Access Compliance Report

Public Rights-of-Way

Intersection ID: 10036443	Main Street: ROYAL_CASTLE_CT	Cross Street: N/A	Location: NE
ADA ID: 7132C3493B4A	Ramp Type: PerpDiag	Initial Pass/Fail: Fail	Overall Compliance: No
Severity Score: 13.75			
Codes/Mitigation Info/Possible Solution		Field Measurements/Component Compliance

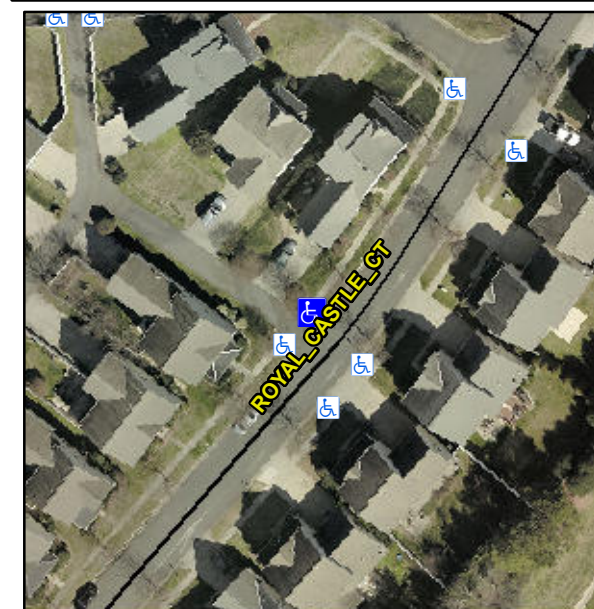
R304.2.2, R304.5.3

Compliance	Description	Data	Compliance	Description	Data
N/A	Ramp Length (in)	76.0	No	Ramp Slope (%)	11.5
Yes	Ramp Width (in)	48.0	No	Ramp XSlope (%)	5.0
N/A	Flare Type LT	N/A	N/A	Flare Type RT	N/A
N/A	Flare Slope LT (%)	N/A	N/A	Flare Slope RT (%)	N/A
N/A	Flare Traversable LT?	N/A	N/A	Flare Traversable RT?	N/A
N/A	Landing Length (in)	N/A	N/A	DWS Provided?	N/A
N/A	Landing Width (in)	N/A	N/A	DWS Contrast?	N/A
N/A	Landing Slope (%)	N/A	N/A	DWS Length (in)	N/A
N/A	Landing X Slope (%)	N/A	N/A	DWS Full Width?	N/A
N/A	Landing Curb? (Y/N)	N/A	N/A	DWS Offset (in)	N/A
N/A	Shared Landing?	N/A			
N/A	Gutter Ponding?	N/A	N/A	Gutter Slope (%)	N/A
N/A	Gutter Lip Ht (in)	N/A	N/A	Gutter X Slope (%)	N/A
N/A	Painted X Walk1?	No	N/A	Painted X Walk2?	No
	X Walk 1 Direction	To SW		X Walk 2 Direction	To SE
N/A	X Walk 1 Width (in)	N/A	N/A	X Walk 2 Width (in)	N/A
	X Walk 1 Slope (%)	5.1		X Walk 2 Slope (%)	2.2
	X Walk 1 X Slope (%)	1.3		X Walk 2 X Slope (%)	5.5

Remove & Replace Curb Ramp With Two New Directional Ramps or Equivalent.
